**DOCUMENT 00 90 00
ADDENDUM**

ADDENDUM NO. [1] Date: February 17, 2020

**RE: WESTERN TECHNICAL COLLEGE
 APPRENTICESHIP CENTER REMODEL
 2860 21ST PLACE SOUTH
 LA CROSSE, WISCONSIN 54601
 HSR PROJECT NO. 19021**

This Addendum consists of [2] page, [1] specification sections and [9] 30 x 42 drawings.

3 SWITCHBOARD DETAIL
E202 N.T.S.

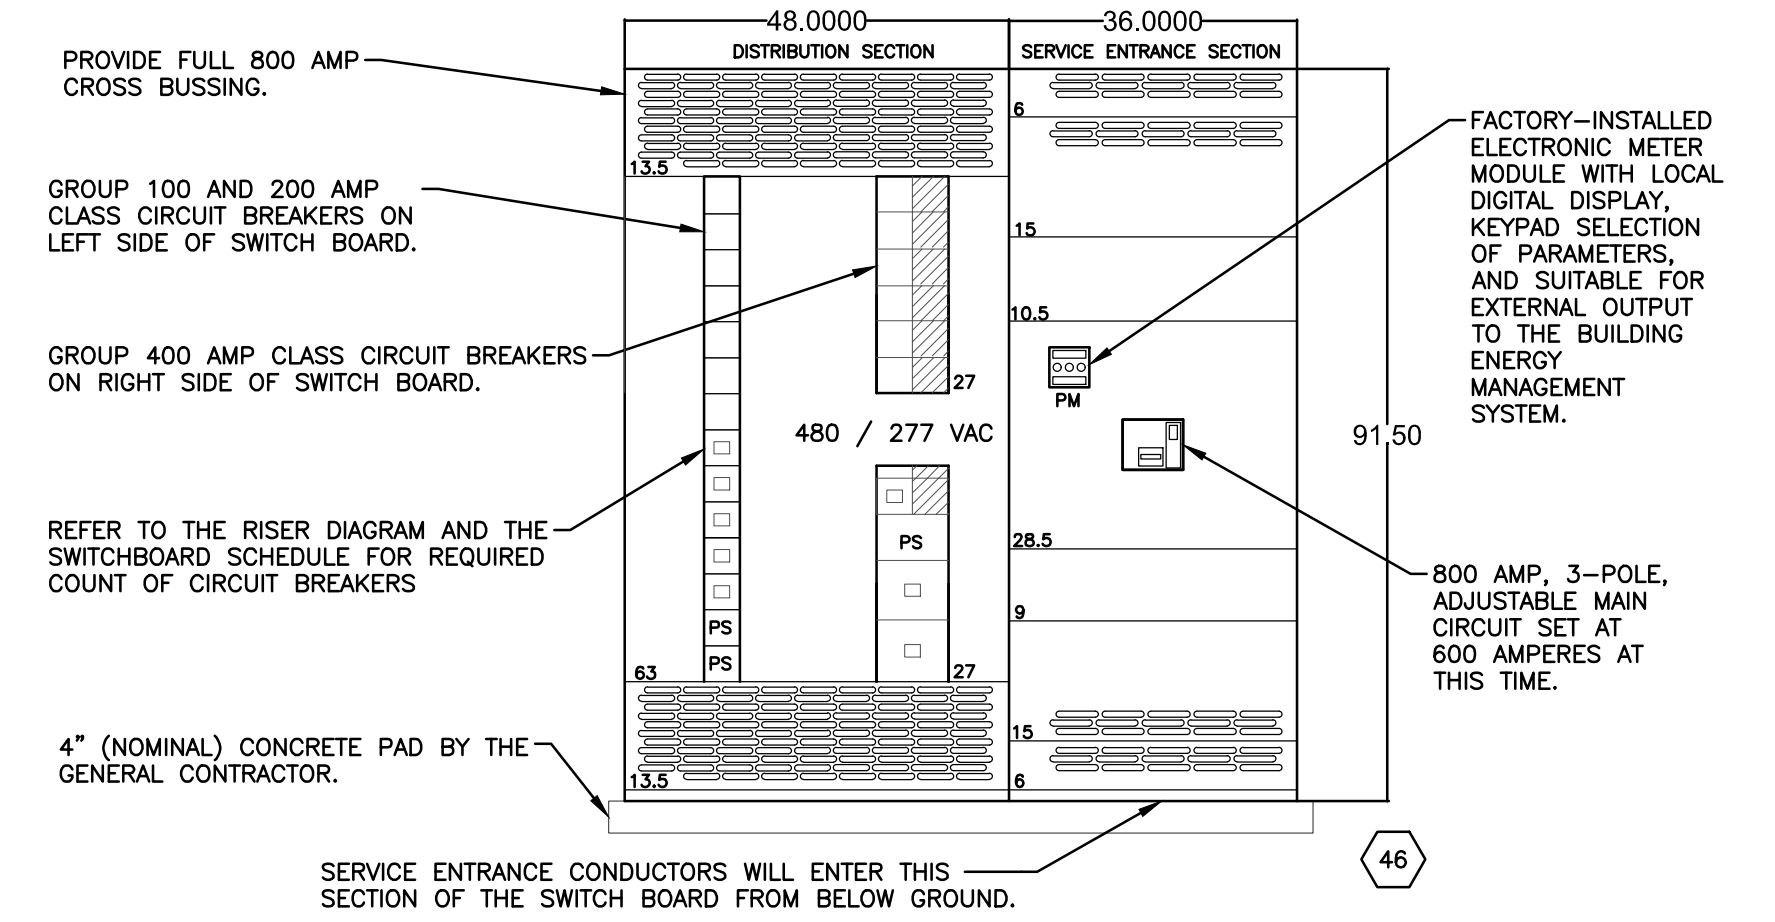
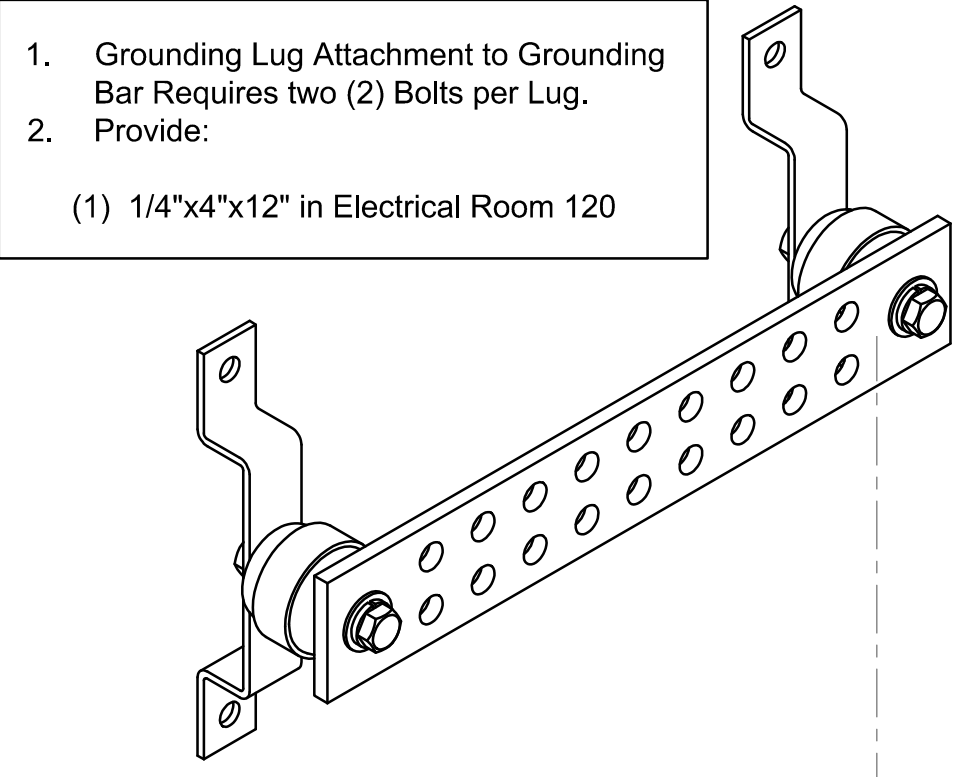
- a. Revisions clouded on Drawing.
12. Sheet E202R ENGLARGED POWER PLAN 30 x 42 attached hereto
 - a. Revisions clouded on Drawing.
